DOCUMENT TITLE: E-PLAN IMPLEMENTING PROCEDURES

CHANGE NUMBER: 214

Subject: Vermont Yankee Nuclear Power Station  
License No. DPR-28 (Docket No. 50-271)  
Vermont Yankee Emergency Plan Implementing Procedure Changes

To: E-Plan Implementing Procedure Controlled Set Holders  
From: Technical Support - DCC - Ann M. Pichette  
Date: 02/25/2003  
Re: VY EPlan Implementing Procedure Change #214, Instruction Sheet

Figure 6  
 OP 3504 Rev. 35  
 Page 1 of 2  
 LPC #2

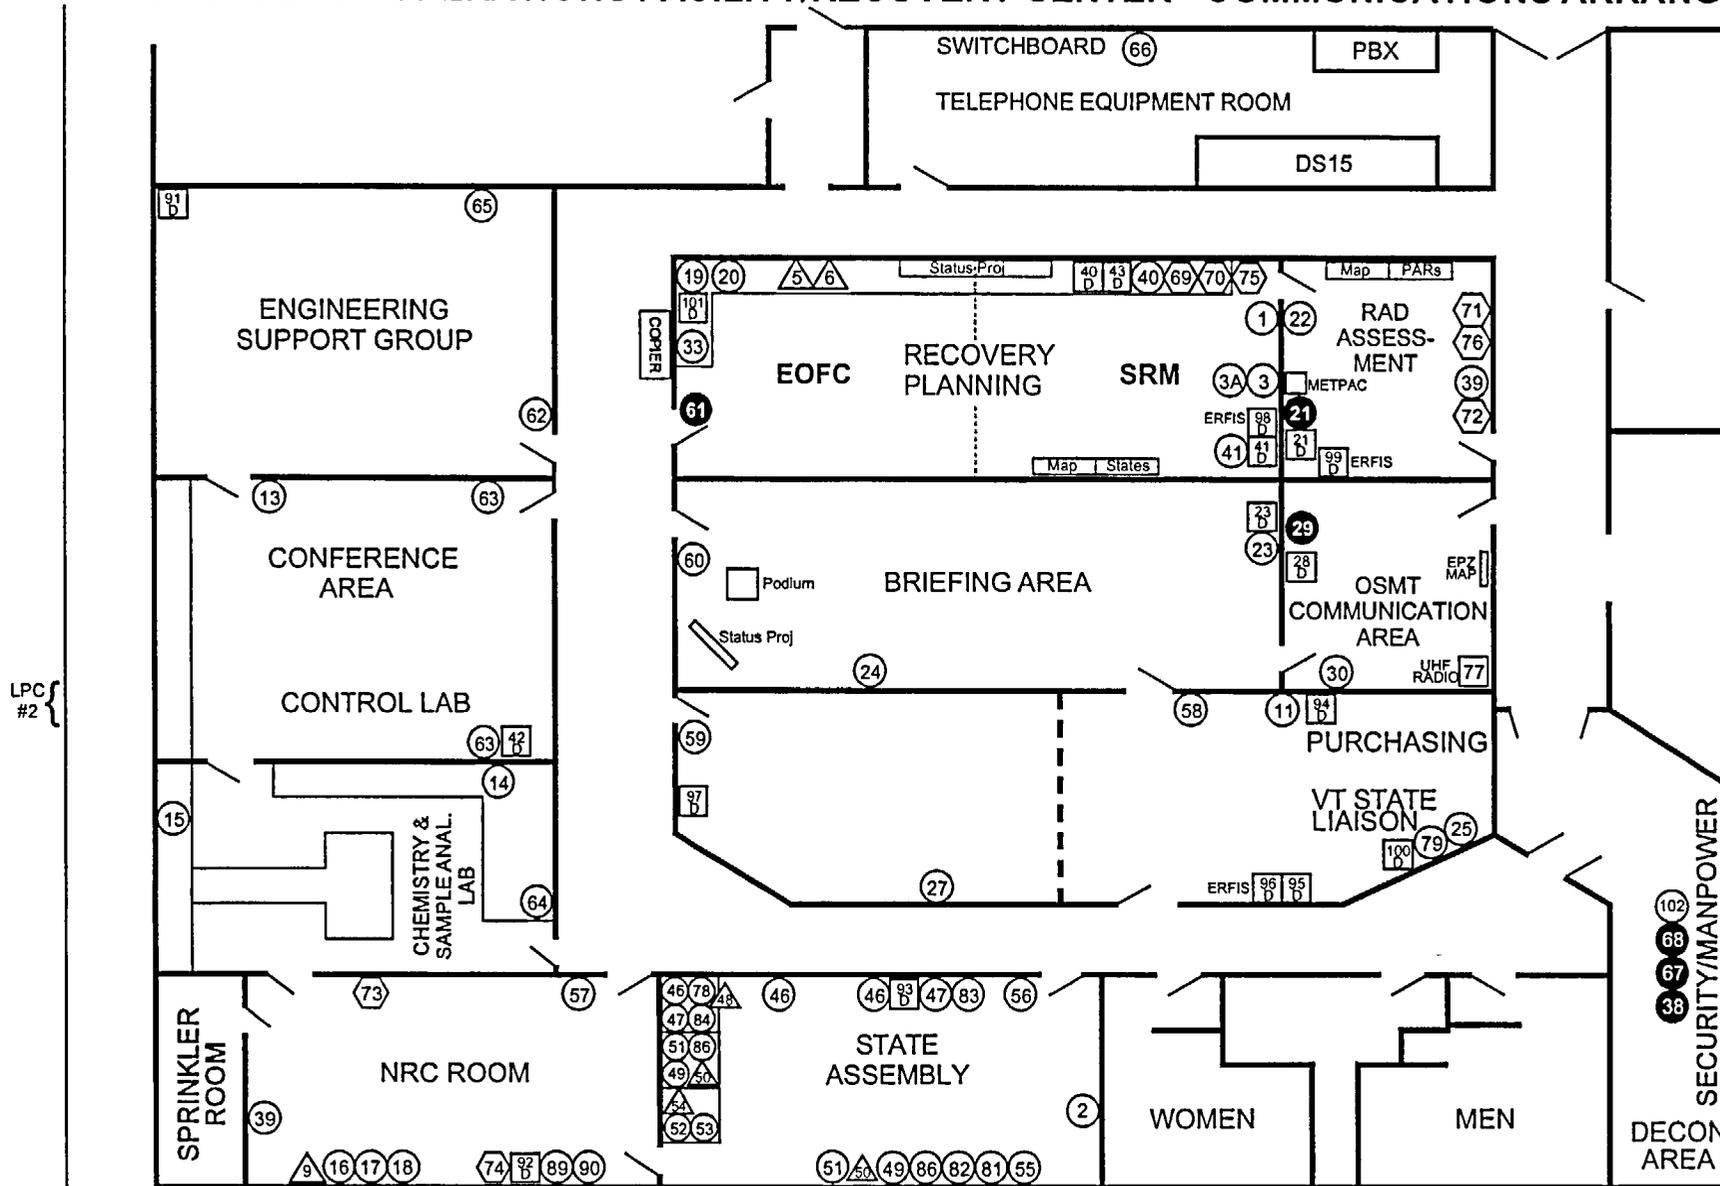
These changes are corrections to the original change of 1/24/03.

Figure 6  
OP 3504 Rev. 35  
Page 1 of 2  
LPC #3

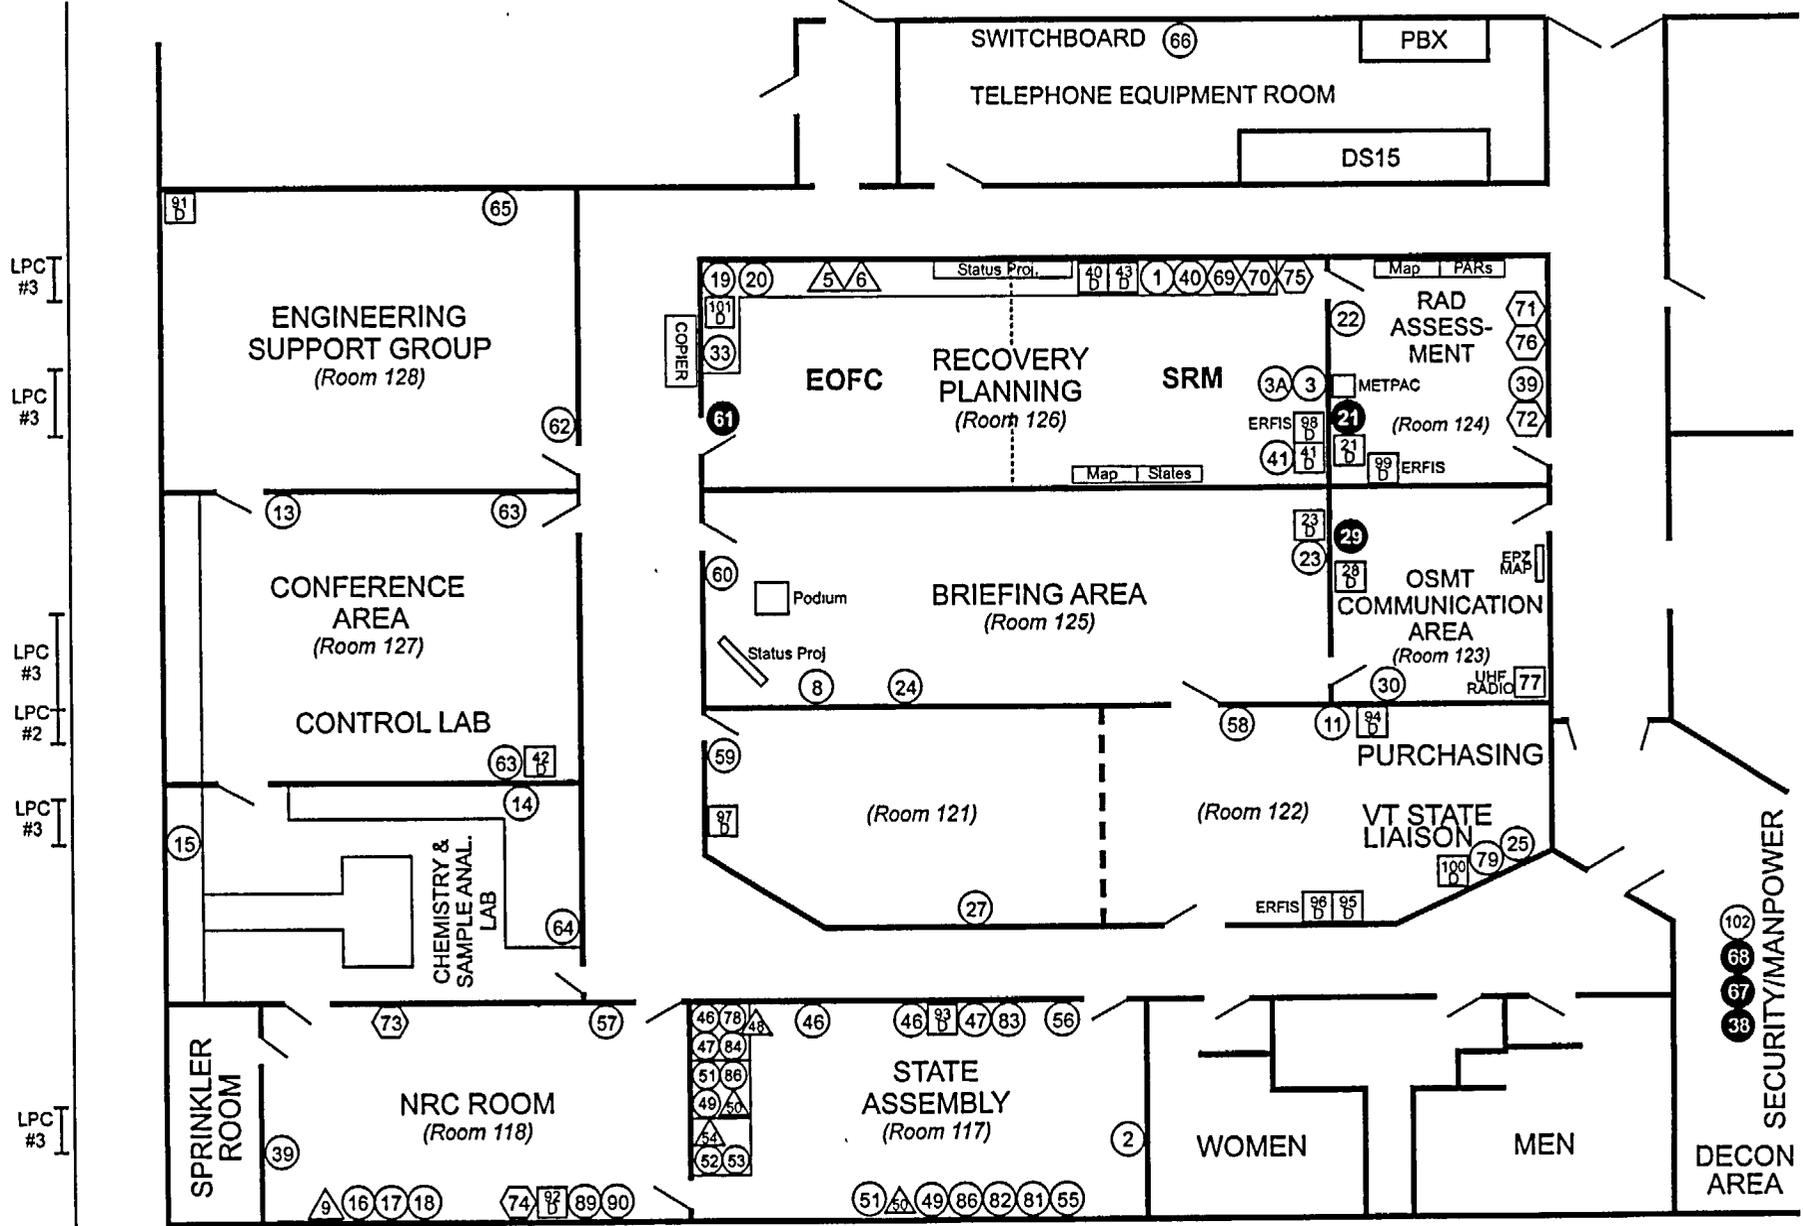
Changes are minor and are a follow-up enhancement to the original EOF floor plan change. Changes to Appendix B are phone number changes and are editorial. None of the changes decreases the effectiveness of the Emergency Plan and it continues to meet all requirements.

Figure 1  
OP 3541 Rev. 1  
Page 1 of 1  
LPC #2

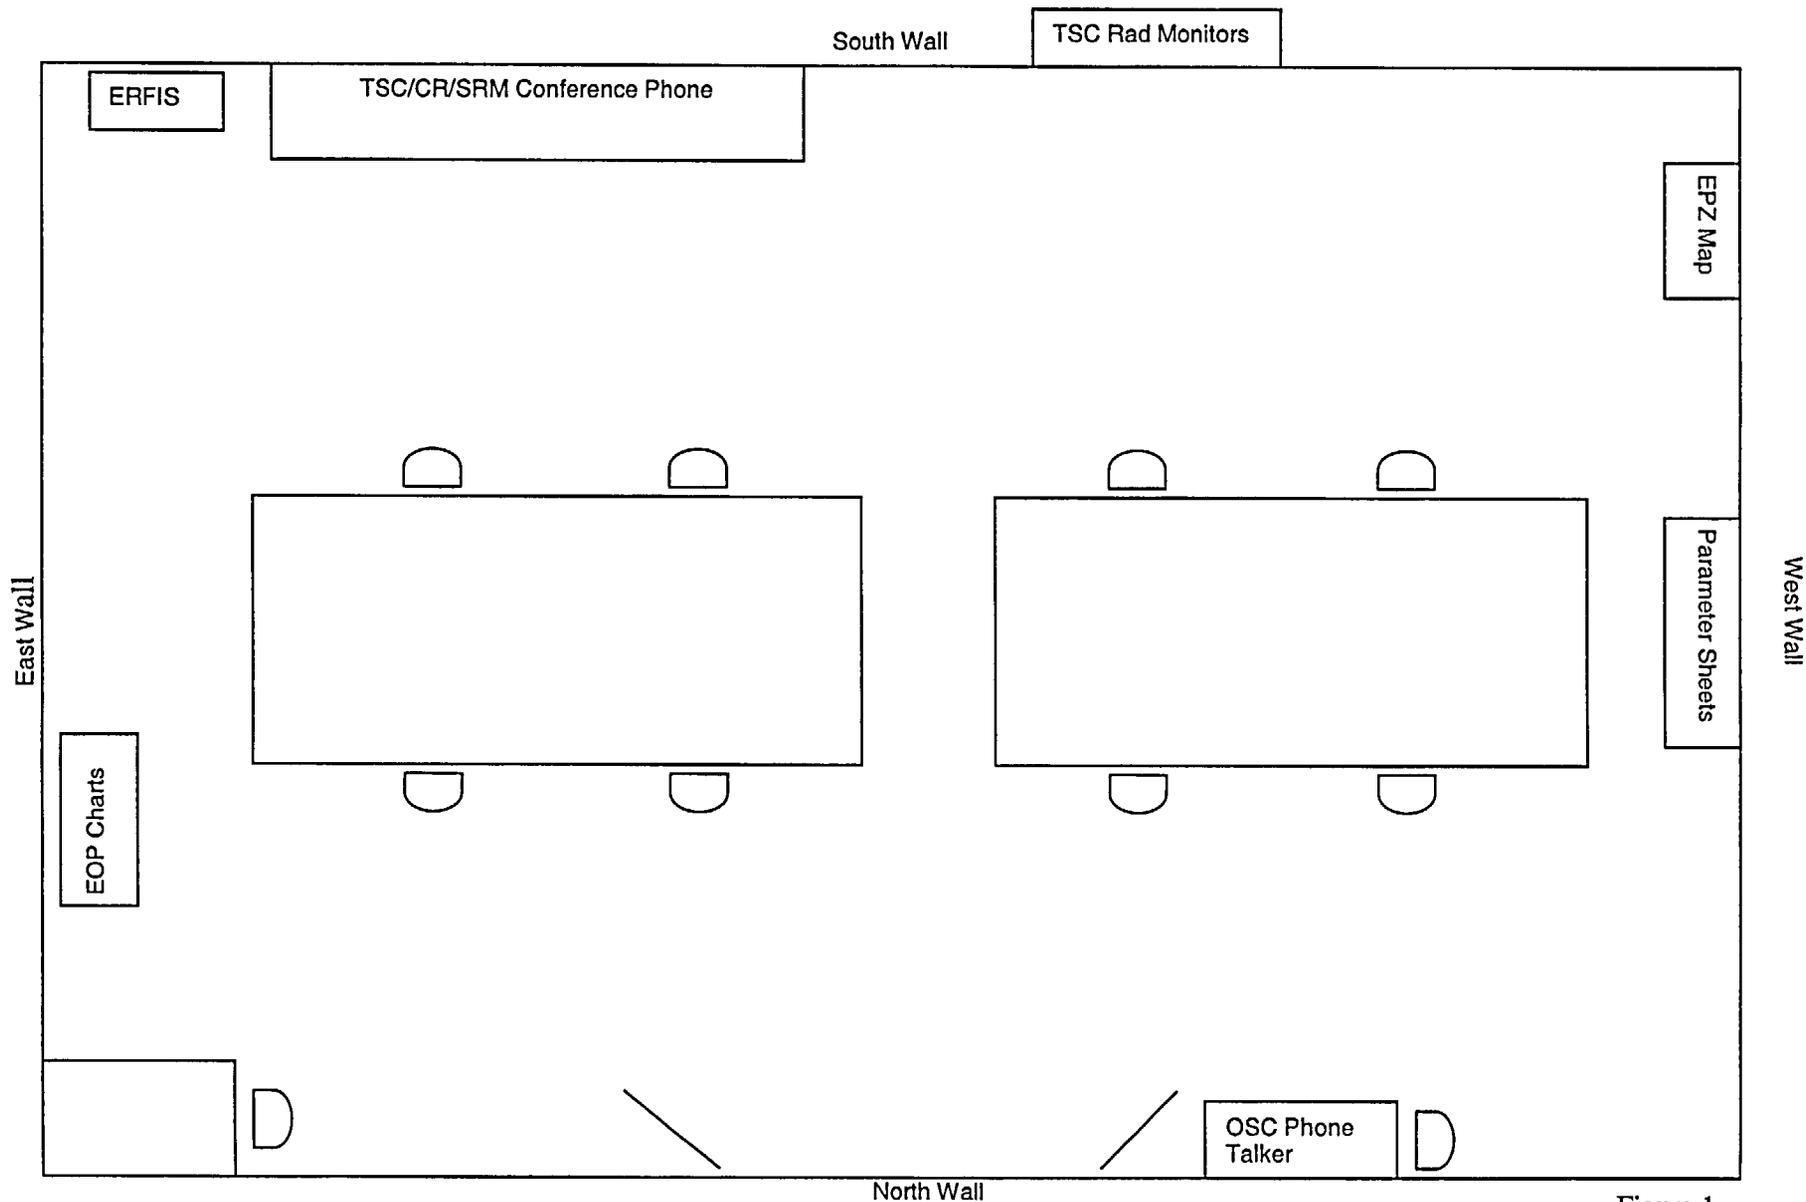
The change allows flexibility with the setup of the TSC. Should staff need to make changes to the layout that are not detailed on Figure 1, this gives them the flexibility without violating the procedure. This does not decrease the effectiveness of the Plan and it continues to meet all requirements.
